Southern Nuclear Operating Company
Vogtle Electric Generating Plant Units 3 and 4 Combined License Application
Supplemental Response to Request for Additional Information Letter No. 029

Supplemental Response to NRC RAI Letter No. 029

FSAR Section 13.3, Emergency Planning

eRAI Tracking No. 2087

Revised Site Plan Figure

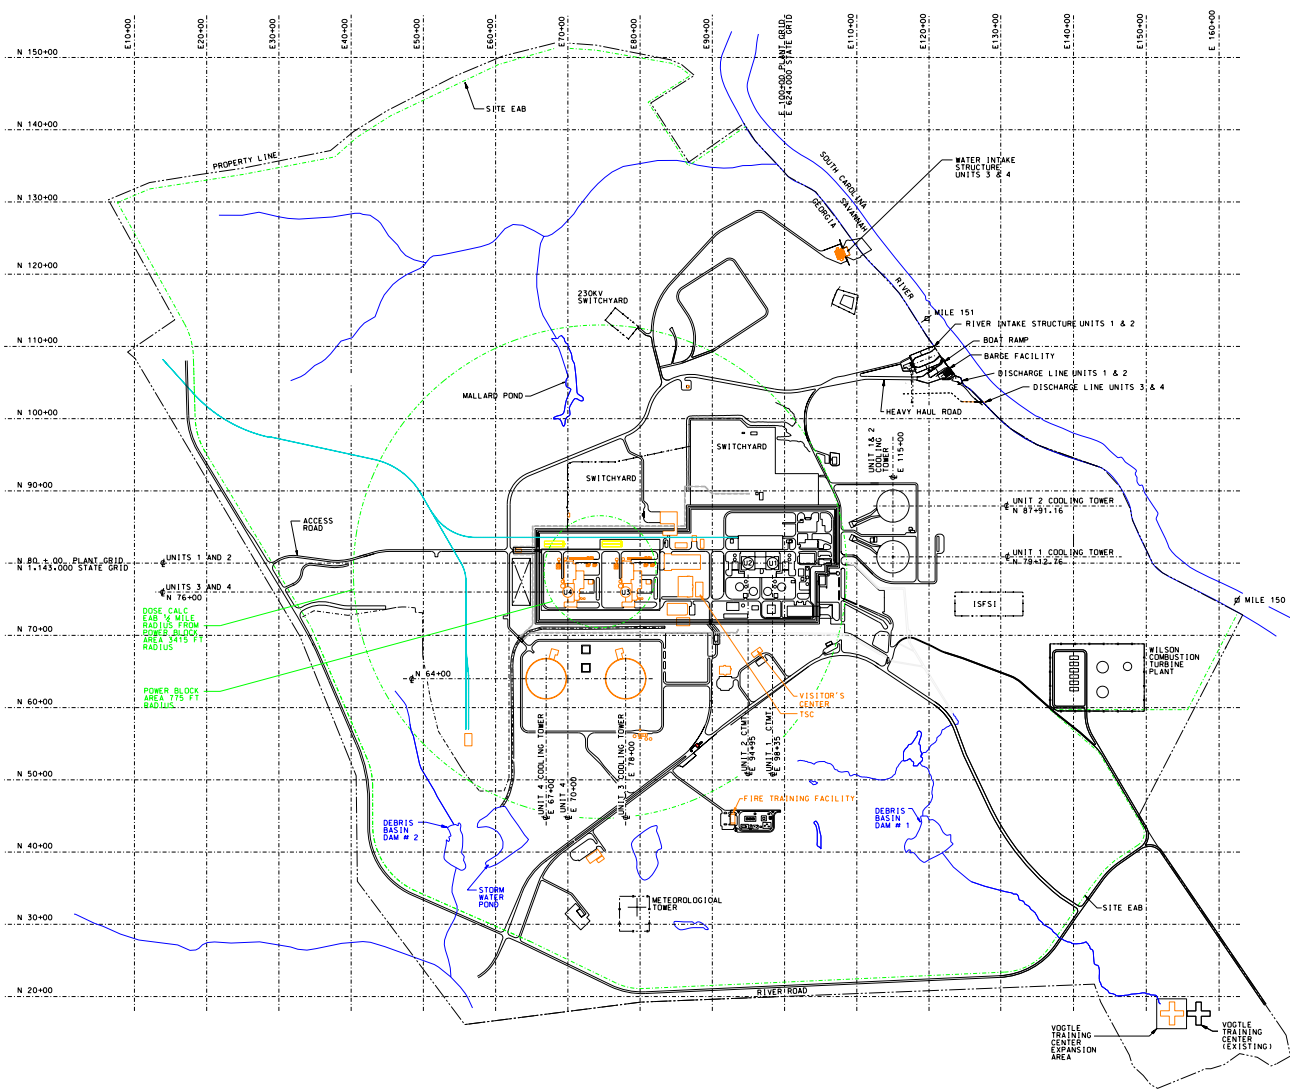
Figure ii, which shows the entire VEGP site on a very small figure, does not allow the identification of the TSC's specific location in regard to other significant site features. Figure 13.3-2, "VEGP Site Map," in the Vogtle ESP application (Part 2, Revision 0, August 2006, page 13.3-12) is somewhat clearer, yet also does not show the TSC's detailed location in relation to other major site structures and security boundaries.

Please provide a readable figure(s) (and description, if appropriate) that clearly shows the proposed TSC location in relation to the site's significant features and structures, including Units 1 through 4 power blocks, and major security barriers/boundaries and checkpoints. In addition, provide the TSC's approximate distance (in feet/meters) from the site's vital areas.

The location of the TSC is shown on the revised "Vogtle Electric Generating Plant Site Plan" (see Enclosure 2), which will be provided as a replacement Emergency Plan Figure ii in a future COLA revision. The TSC will be located in the lower level of the Communication Support Center. The Communication Support Center is located adjacent to the Maintenance Building and near the Engineering and Administration Building. This complex of buildings is located within the Protected Area between the Unit 2 and Unit 3 power blocks. Please note that the grid lines on the revised figure are at 1000 ft. intervals. The distance from the TSC to the Unit 4 control room is about 1700 ft., and the distance to the Unit 3 control room is about 1000 ft. It is estimated that the walking distance from the TSC to the Unit 4 control room will be about 2500 ft. and 1800 ft. to the Unit 3 control room. A delay fence is located between the TSC and the Units 3 and 4 power blocks. Entrance through the delay fence will be through a card keyed gate. Motorized vehicles will be available for transport of personnel between the TSC and Units 3 and 4 vital areas.

"Replace Preface page xiii, Figure ii, Vogtle Electric Generating Plant Site Plan, with the attached Preface Figure ii.
